Wiltshire Council Planning Consultation Response

Application No: **PL/2023/03881 & PL/2023/04024**
Conversion of redundant barn to residential use to include minor extension replacements
The Barn, Oatridge Farm, Eastcourt, Malmesbury, SN16 9HR

Assessment: This is my third consultation response and follows the submission of amended plans.

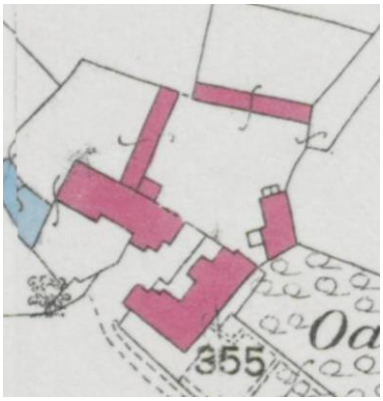
Layout – As seen from the 1st Edition OS map below, the partly existing modern concrete block structures to the north east elevation are not original and detract from the character of the existing barn. The barn would be enhanced through their removal and the original appearance of the barn reinstated. This would also provide a focus on the original main cart entrance as the primary feature on the front elevation.

As such in conservation terms the preference would be to remove these modern structures rather than replace them. I am also concerned that the replacement of the north eastern extension would necessitate the knocking through of a doors way in the cart entrance when there does not appear to be a precedent for this opening (unless the applicant can provide evidence of a historic door opening) - this would cause loss of plan form and historic fabric.
